CAMPLAS FCA – RESPONSE to NRW Comments.

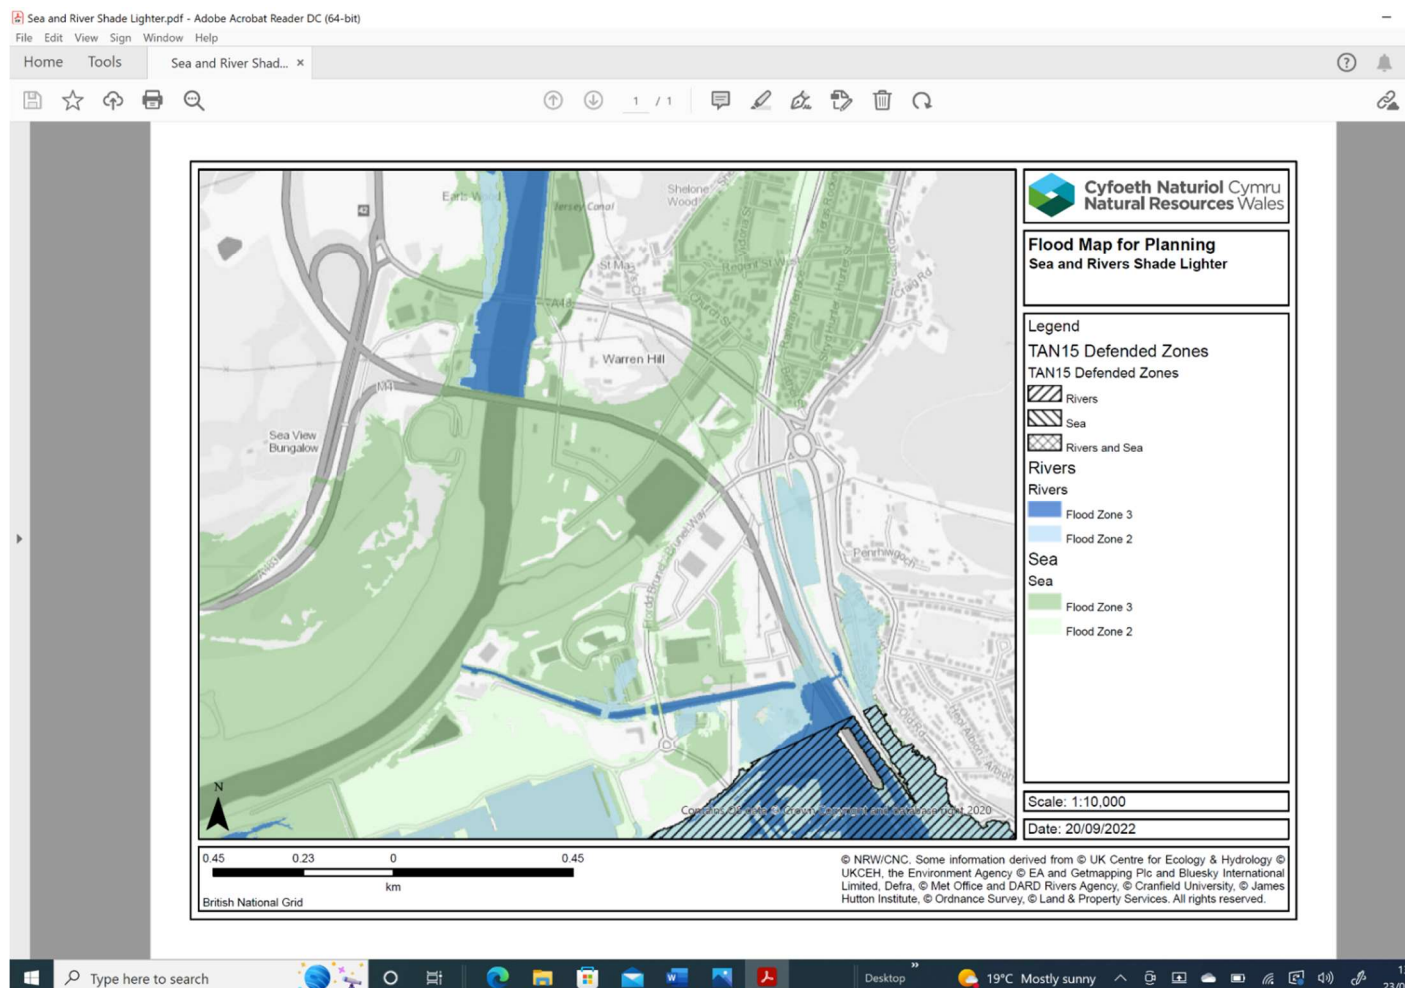
As NRW states, the formal fluvial food mapping is terminated at the M4 bridge (Section 4 boundary). River flooding does not appear to extend east of the quay wall at the M4 bridge and this is likely to be replicated with diminished potential detrimental effect applying downstream of the bridge for the reasons expressed herein.

The Camplas site is located in an area which is dominated by tide and may be described as estuarial and under the overriding influence of sea water levels. The typical river/ low tide cross section, and thus river flow volume represents a tiny fraction of the sea water component and is insignificant. This is particularly applicable when considering the associated flood plain areas and vanishingly small risk of a joint probability event where the river may be in spate. Bearing in mind the contingency which has been added to the proposed threshold level in the FCA, it is argued that the arrangement as presented will be adequate to address all concerns in relation to flood risk.

To elaborate on the flood plain rationale, it is worth emphasising that the influence of river flow on still water level will be significantly attenuated for the relatively high water values under consideration. The catchment area between the A474 Neath bridge and A48 Briton Ferry bridge increases greatly as the flood plains come into service. This would not be the case upstream of the A474 where fluvial inputs would increase pressure on the restricted catchment under the influence of tide/ tidal reach. The site is immediately adjacent to the estuary and close to open water in an area which is dominated by tide rather than fluvial effects.

It should also be borne in mind that the peak tide levels are only present for very short period of time that may be measured in minutes rather than hours. The influence of river inputs into the flood plain upstream and then the dissipating effect of the geometry of an already extensive flooded area renders fluvial effect as insignificant. It is also worth noting that the chances of a 1:1000 year tidal flood coinciding with, for example, a 1:100 year fluvial flood event would be 1:100,000 years. Not only are the effects of fluvial inputs insignificant but the risk of a joint probability event with two peaks occurring with minutes of each other at the same location would render further consideration unnecessary.
